Date: October 28, 2005

To: T10 Committee (SCSI)

From: George Penokie (IBM/Tivoli)

Subject: SAM-4: Converting to UML part 1

Figure 1 — NonSCSI example of class and object representation

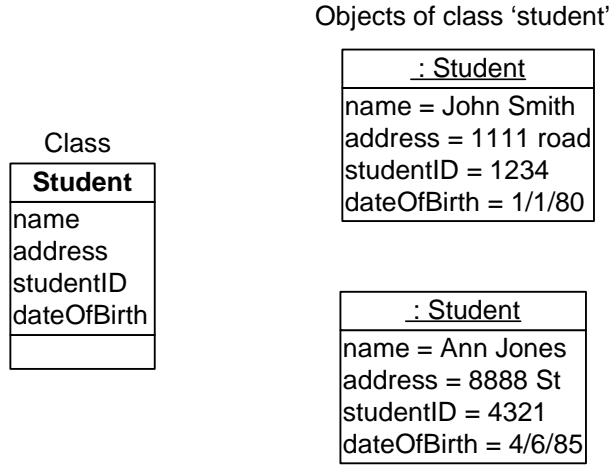
For a non-SCSI example of classes and objects see figure 1. For a SCSI example of classes and objects see figure 2.

Figure 4 — Logical unit class diagram

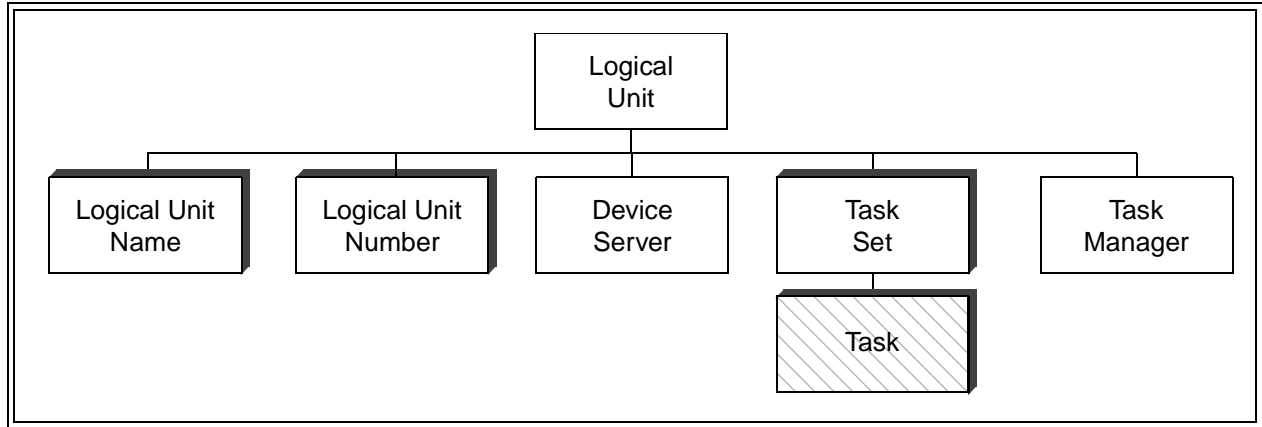
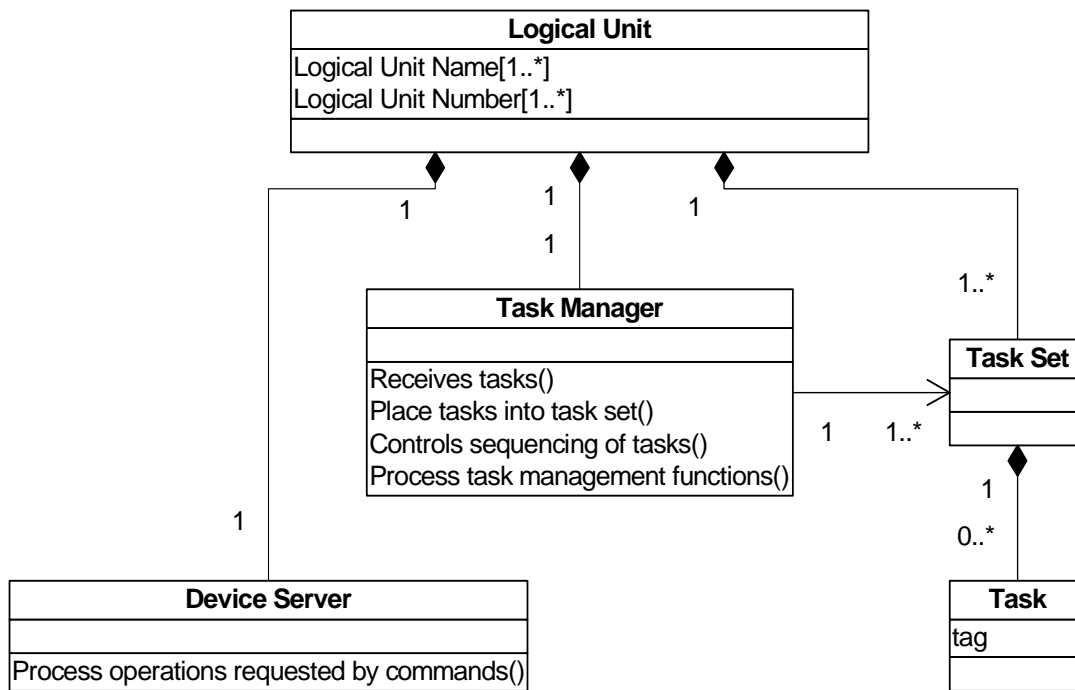
For an example of what figures in SAM-4 would look like a converted logical unit model (see figure 3) as currently shown in SAM-4 would look like what is shown in figure 4.
